711 CS-02 Before

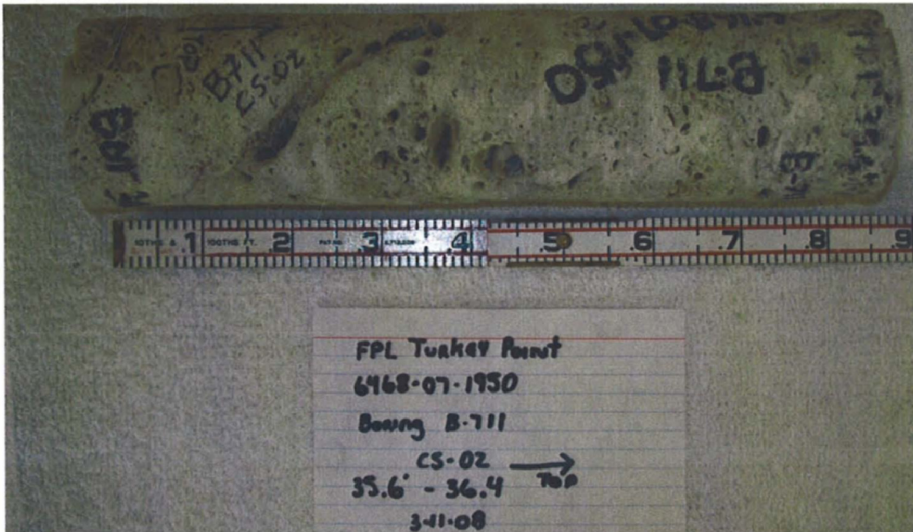
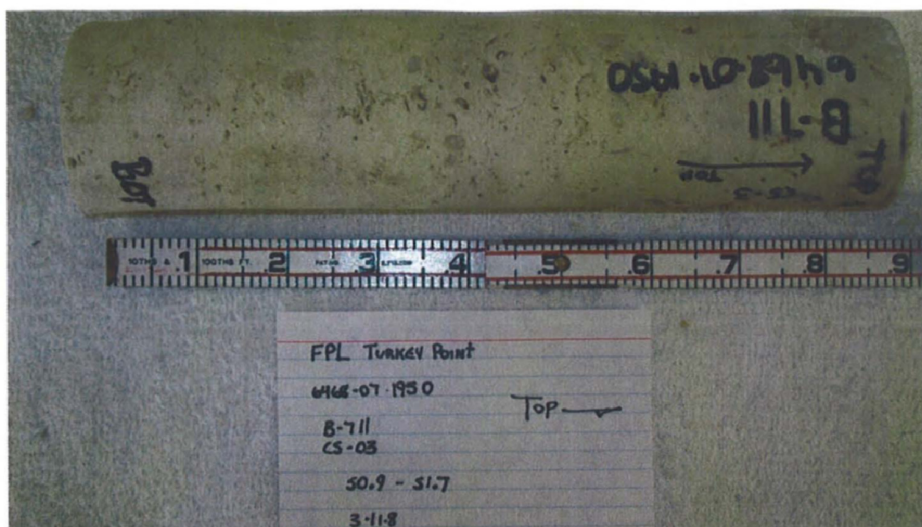
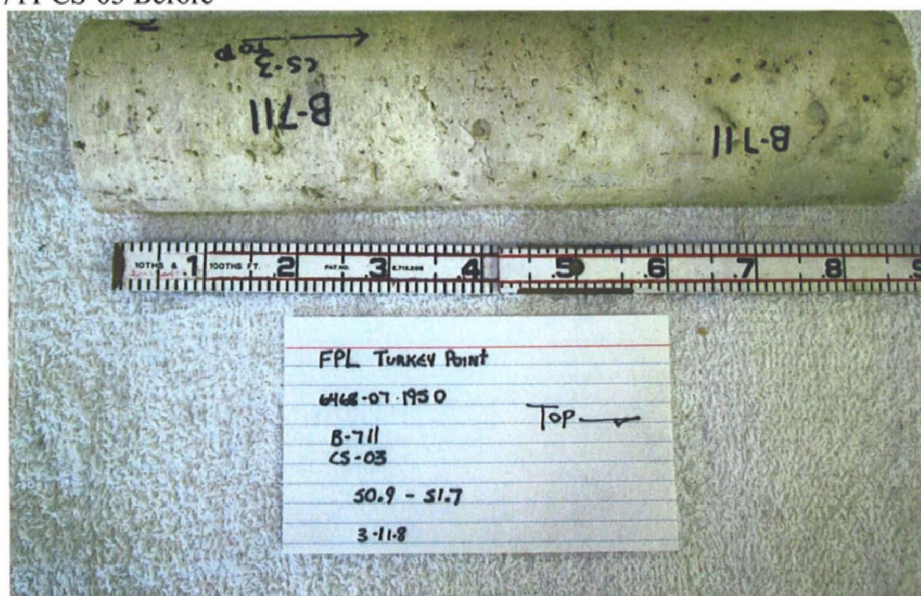
711 CS-02 After

711 CS-03 Before

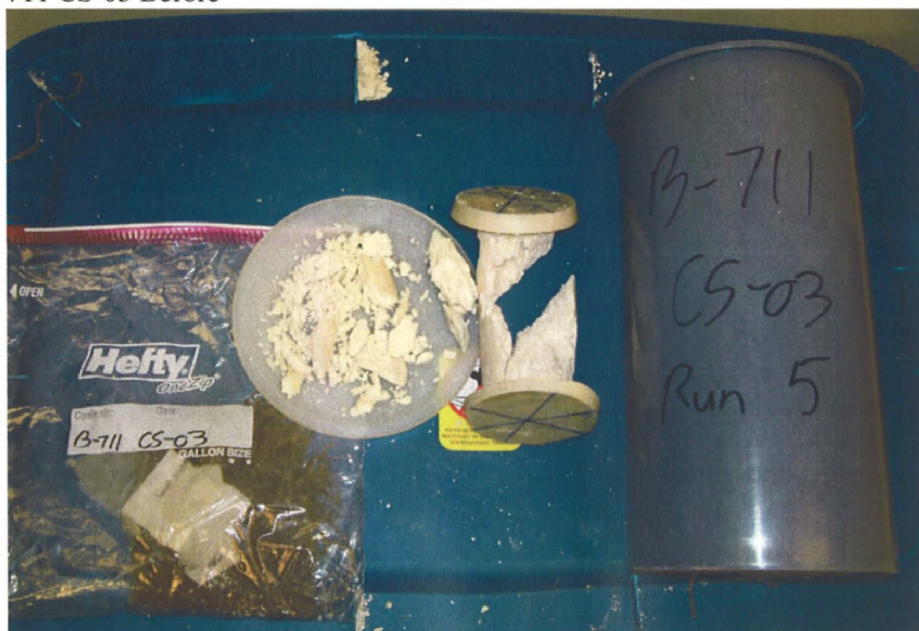
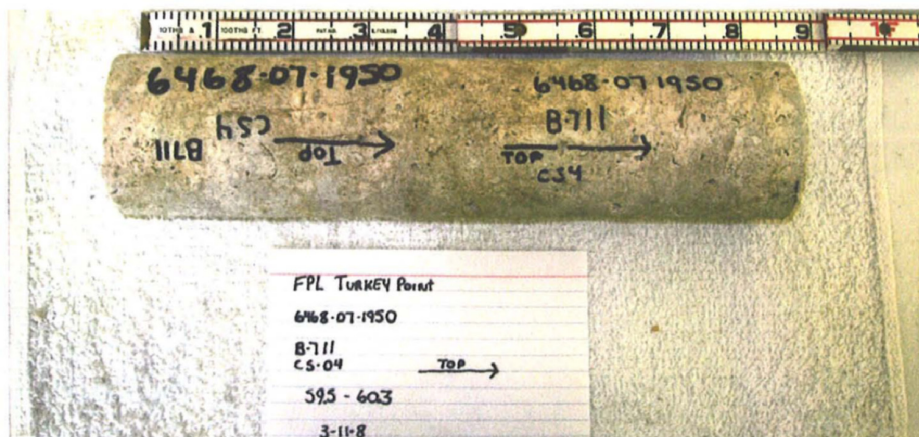
711 CS-03 After

711 CS-04 Before

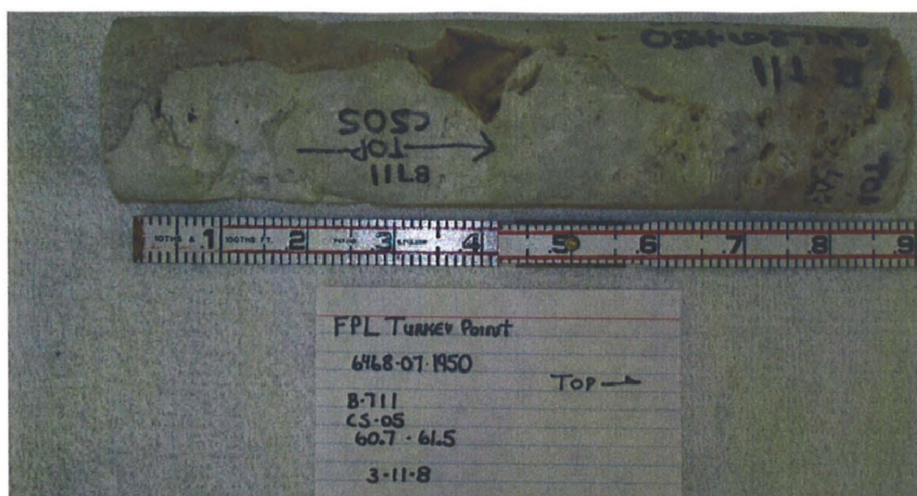
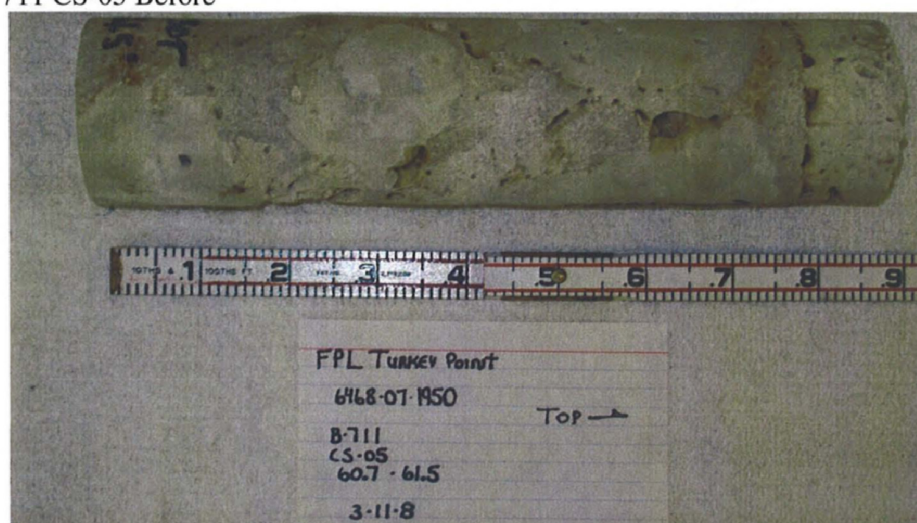
711 CS-04 After

711 CS-05 Before

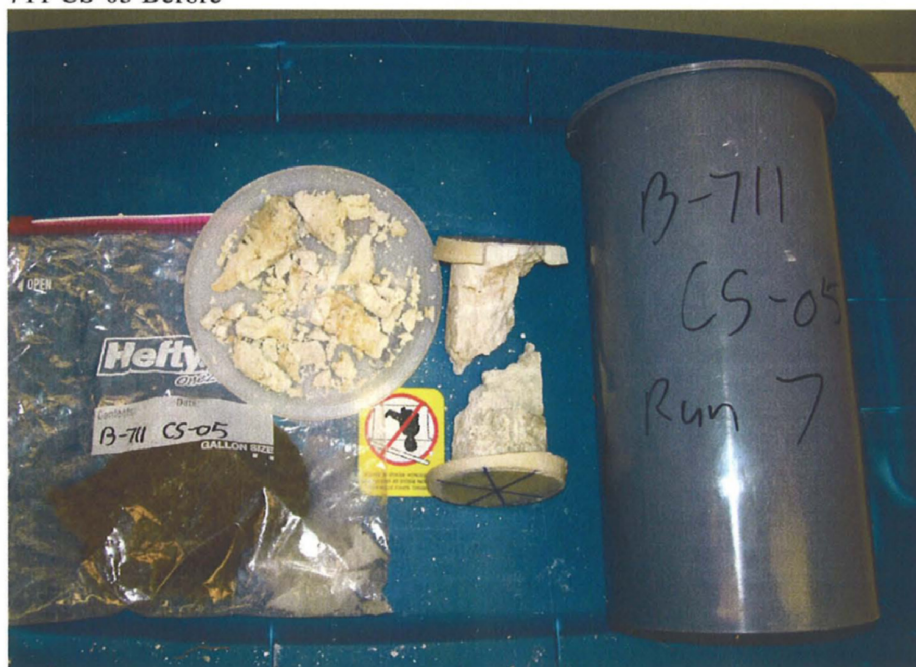
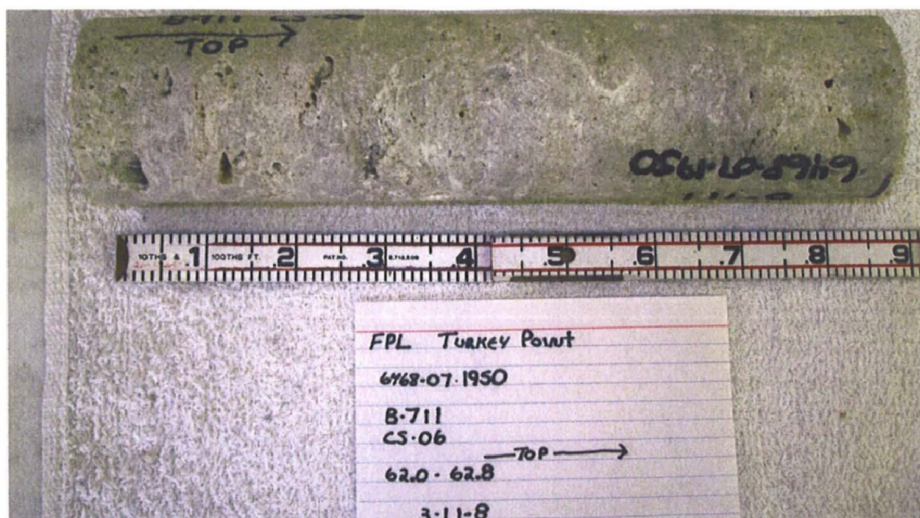
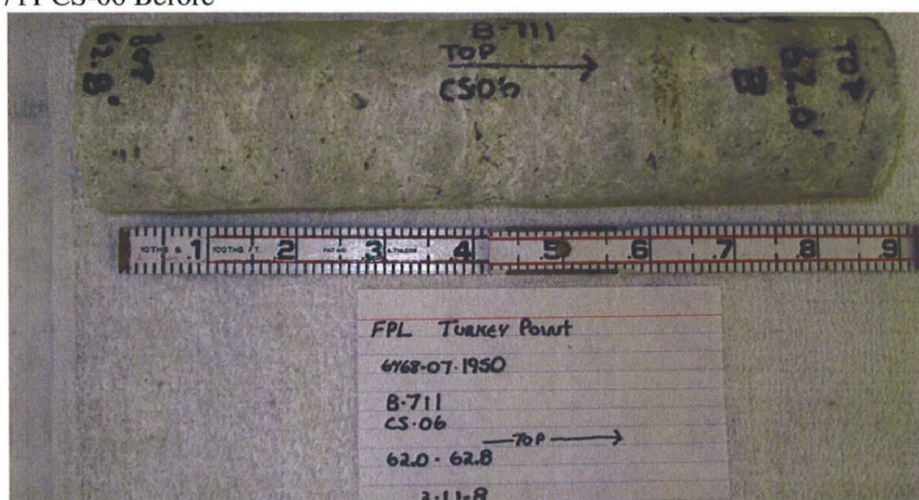
711 CS-05 After

711 CS-06 Before

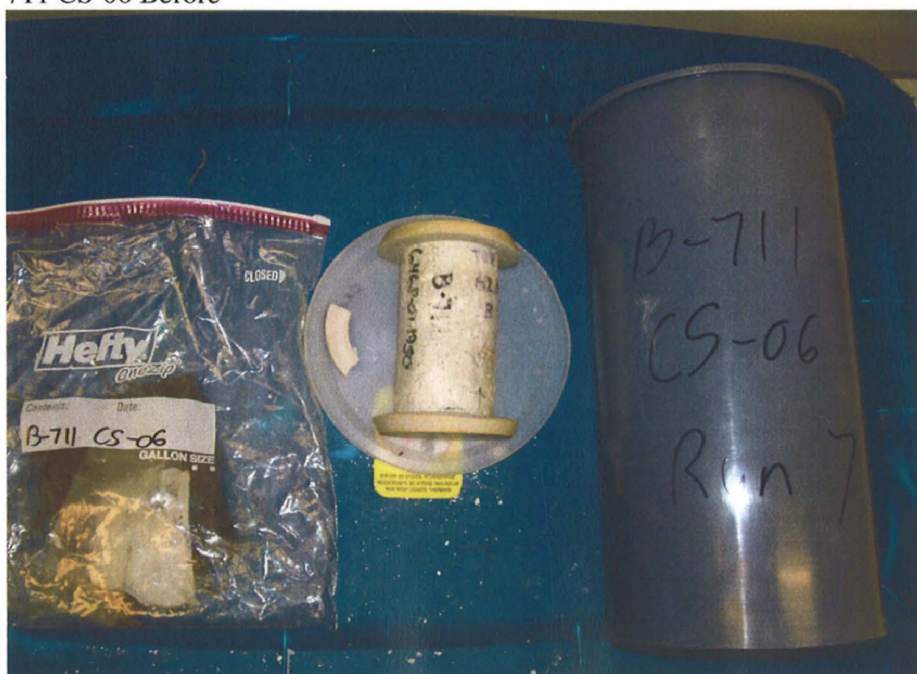
711 CS-06 After
